Product Change Notification / RMES-14WQGP950

CCB 5301 Final Notice: Qualification of MTAI as an additional final test site for MIC210xYML device family available in 16L VQFN (3x3x1.00mm) package.

Pre and Post change comparison
PCN #: RMES-14WQGP950

Pre and Post Change Summary - Base Quantity Multiple (BQM) per reel

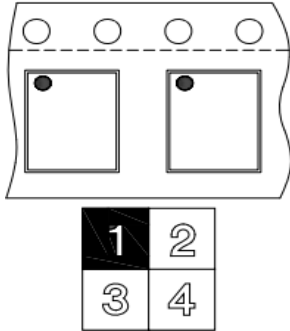
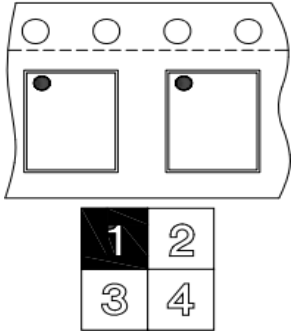
UNIS	MTAI
Units per reel: 5000	Units per reel: 5000

Pre and Post Change Summary - Carrier Tape

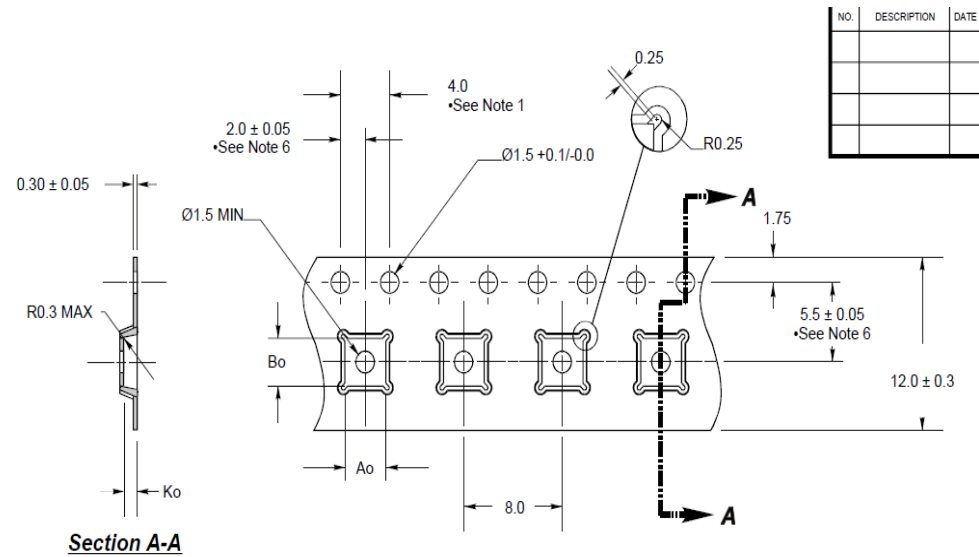
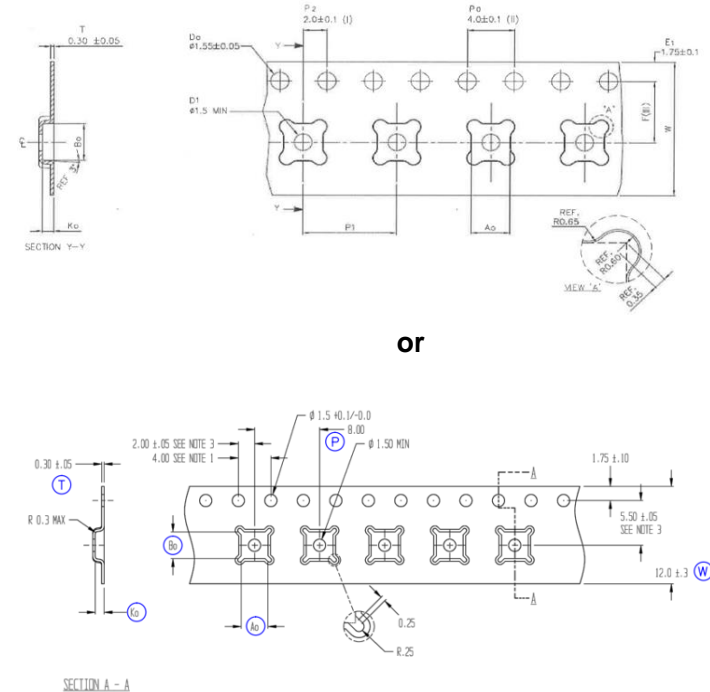
Plant	W (mm.) ± 0.3 or Specific	P (mm.) ± 0.1 or Specific	$A_0 \pm 0.1$ or Specific	$B_0 \pm 0.1$ or Specific	$K_0 \pm 0.1$ or Specific
UNIS	12mm ± 0.3	8.00mm	3.30mm	3.30mm	1.10mm
MTAI	12mm ± 0.3	8.00mm	3.30mm	3.30mm	1.10mm or 1.00mm

Pre and Post Change Summary - Cover Tape

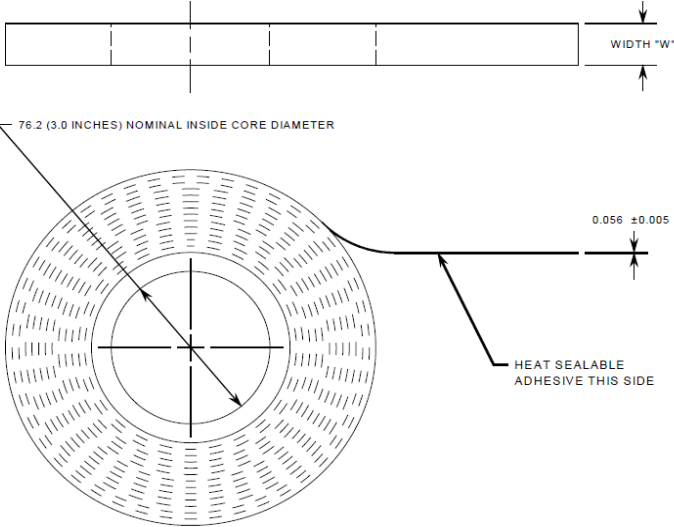
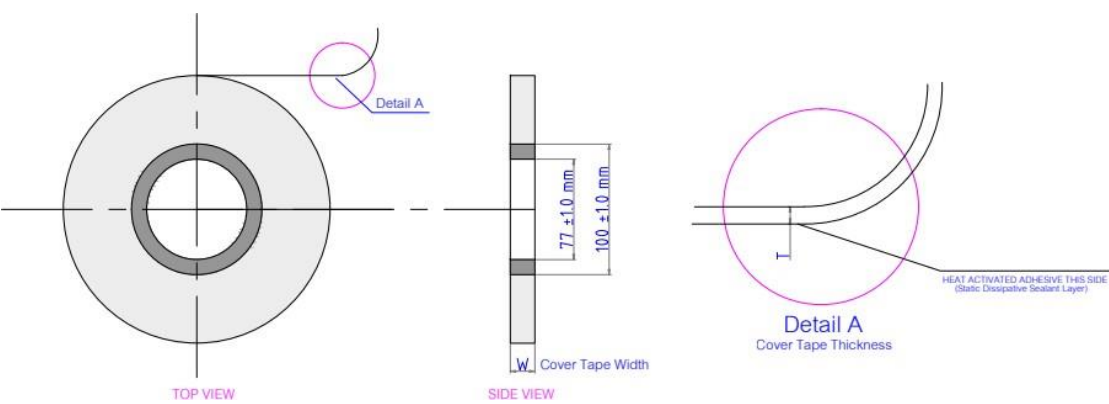
Plant	Cover Tape Width	Thickness	Color	Sealing mythology
UNIS	9.2mm	0.056mm	Clear	Heat Seal
MTAI	9.05+0.05/-0.15mm	0.050 ± 0.010mm	Clear	Heat Seal

Pre and Post Change Summary - Plastic Reel

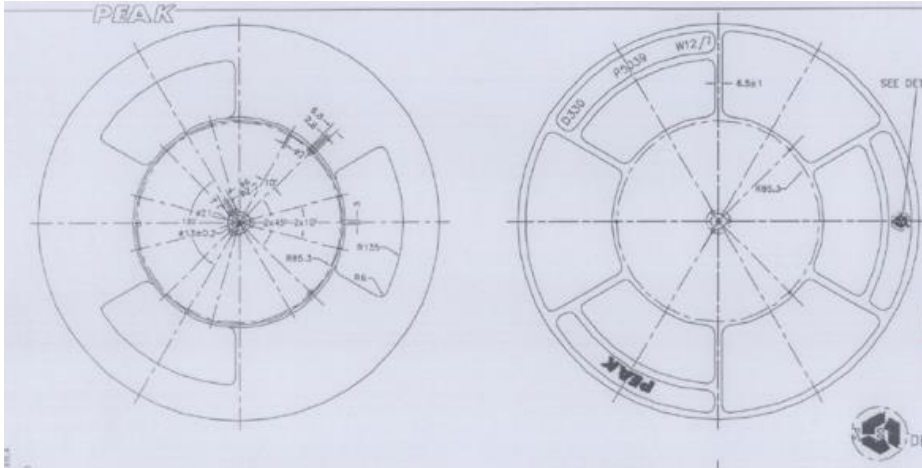
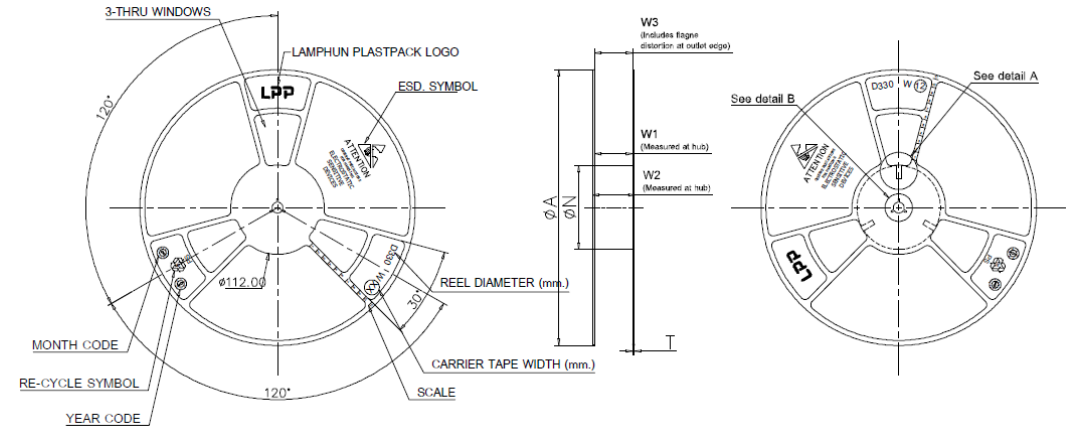
Plant	Reel diameter	Reel Hub Size (mm)	Reel Width Max (mm)	Reel Color
UNIS	330 +4.0/-0.25	177 ±2.0	18.40	White
MTAI	330 +/- 2.0	100 ±2.0	18.40	Dark Blue

Pre and Post Change Summary – Moisture Barrier Bag

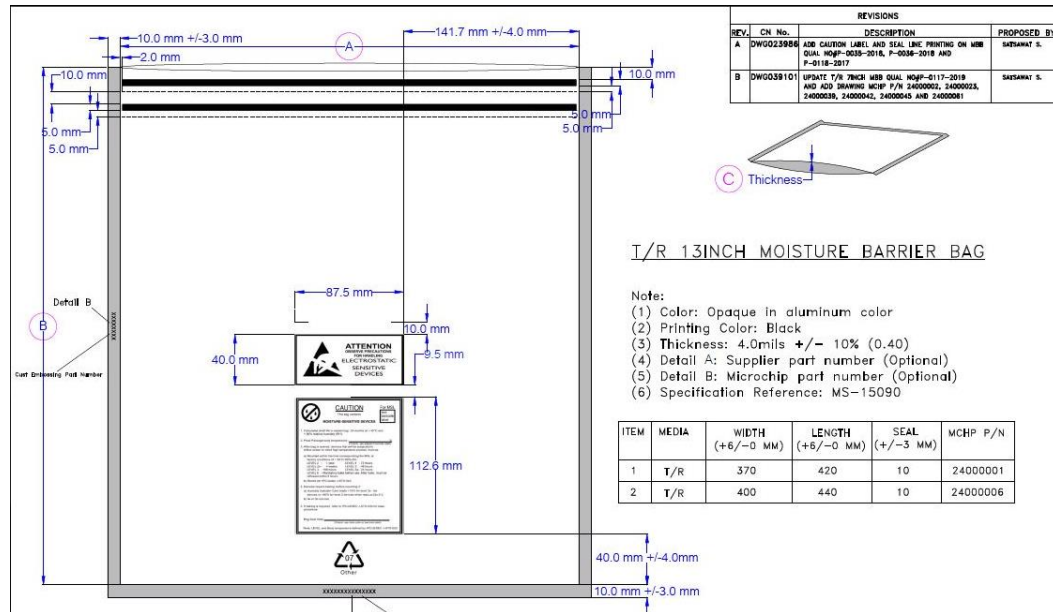
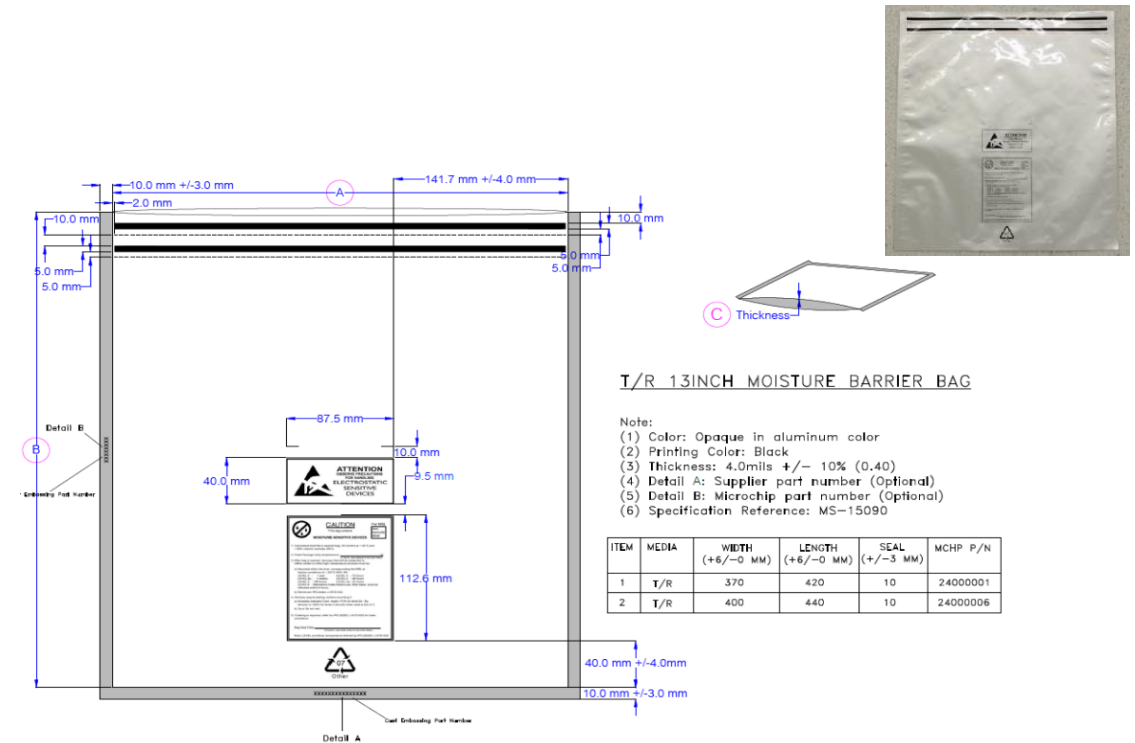
Plant

Length (Inch)

Width (Inch)

Thickness (Mils)

UNIS

16.53

14.56

4

MTAI

16.53

14.56

4
